CITY OF OPELIKA HISTORIC PRESERVATION COMMISSION

August 11, 2022

City of Opelika
Historic Preservation Commission
Staff Report

Photo's:

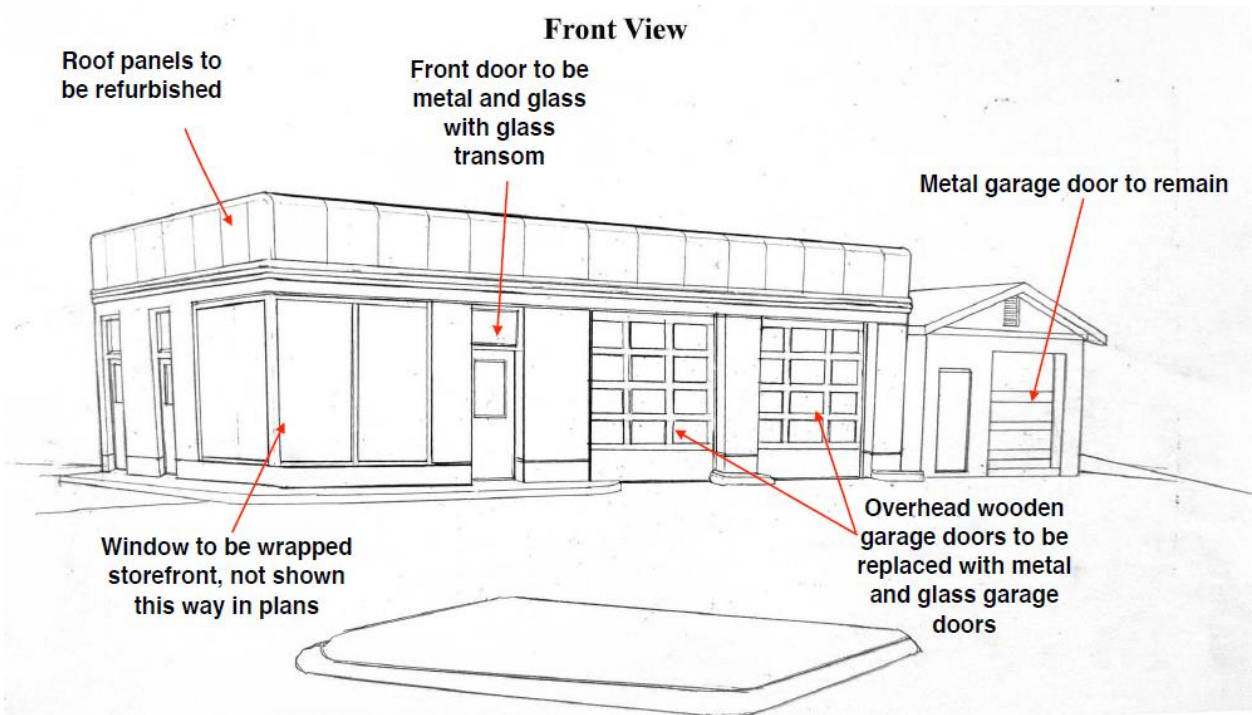
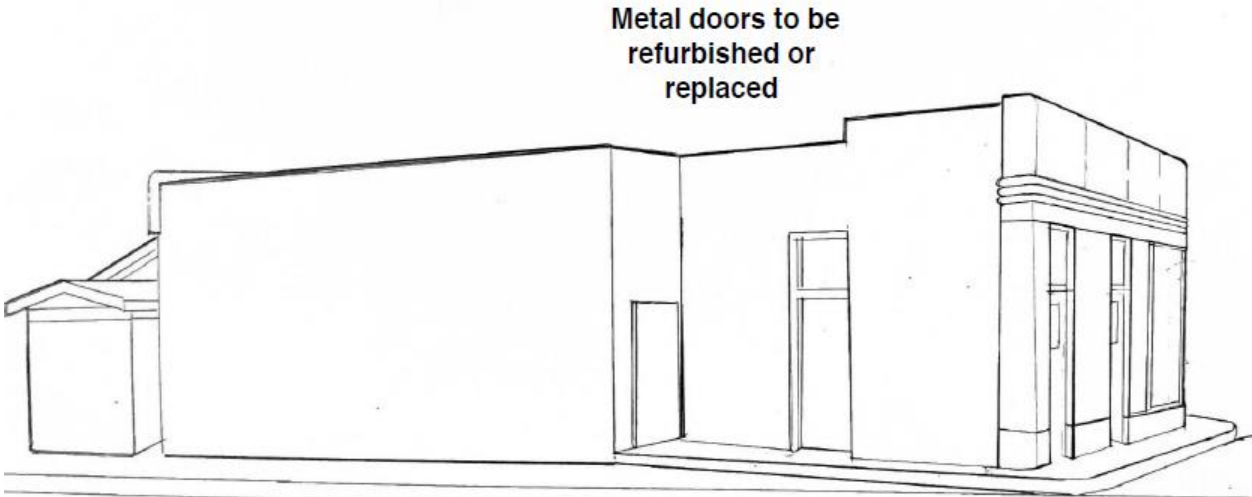
1. Replace wood garage doors with metal and glass roll-up garage doors.
2. Replace roof.
3. Exterior façade to remain the same. Front window left of front door to be continuous. Store front window similar to original (see attached photo). Metal doors to be repainted.

1. Staff recommends approval of new metal and glass roll-up garage doors proposed.
2. Staff recommends approval of roof replacement.

Photo’s:

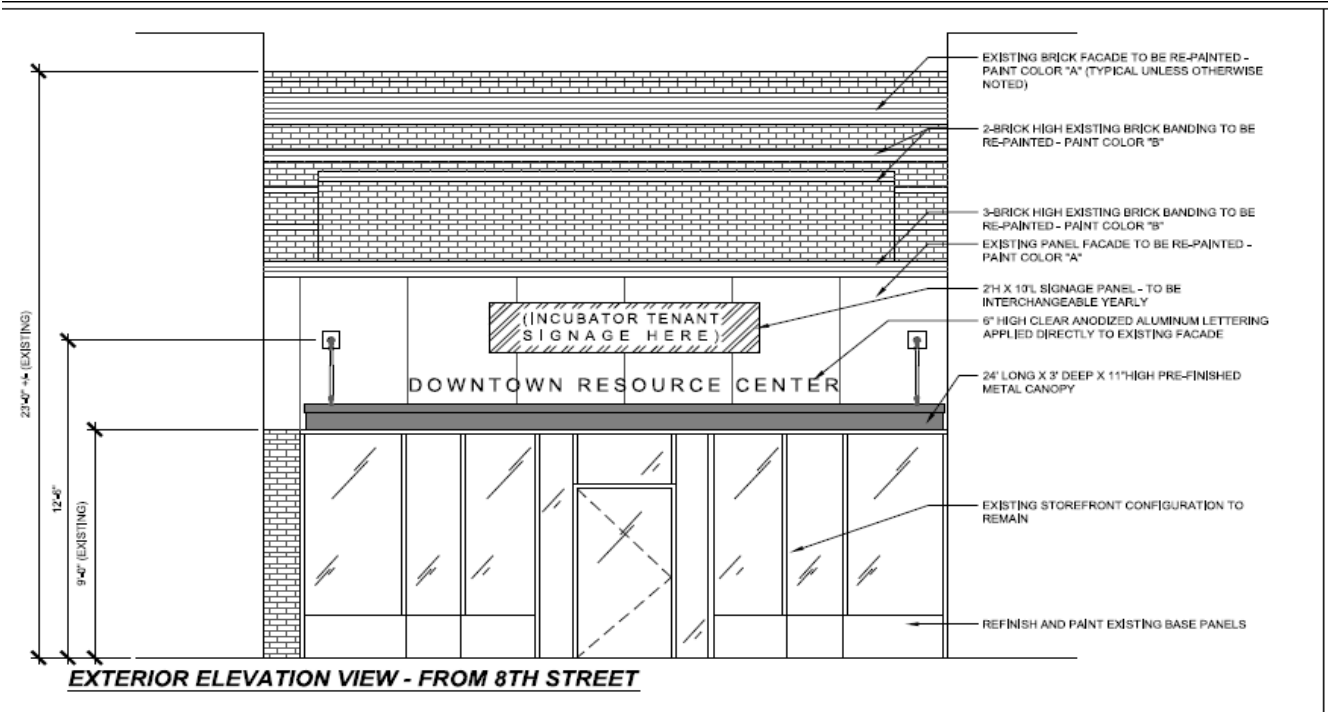
- Existing brick façade to be re-painted-paint color Hale Navy
- 2-brick high existing brick handing to be re-pinted Providence Olive
- 3-brick high existing brick banding to be painted Providence Olive
- Existing panel façade to be re-painted Hale Navy
- 2’H x 10’L signage panel to be interchangeable yearly
- 6’H aluminum lettering applied directly to existing façade
- 24’L x 3’D x 11”H pre-finished metal canopy
- Existing storefront configuration to remain
- Refinish and paint existing base panels

- 1 Staff recommends approval of flat metal awning with rods.
- 2 Staff recommends approval of gooseneck lighting.
- 3 Staff recommends approval of façade sign. However, Staff does recommend that each year new interchangeable sign is submitted for Staff approval. Staff recommends approval of aluminum lettering signage. All signage meets the required square footage allowance.
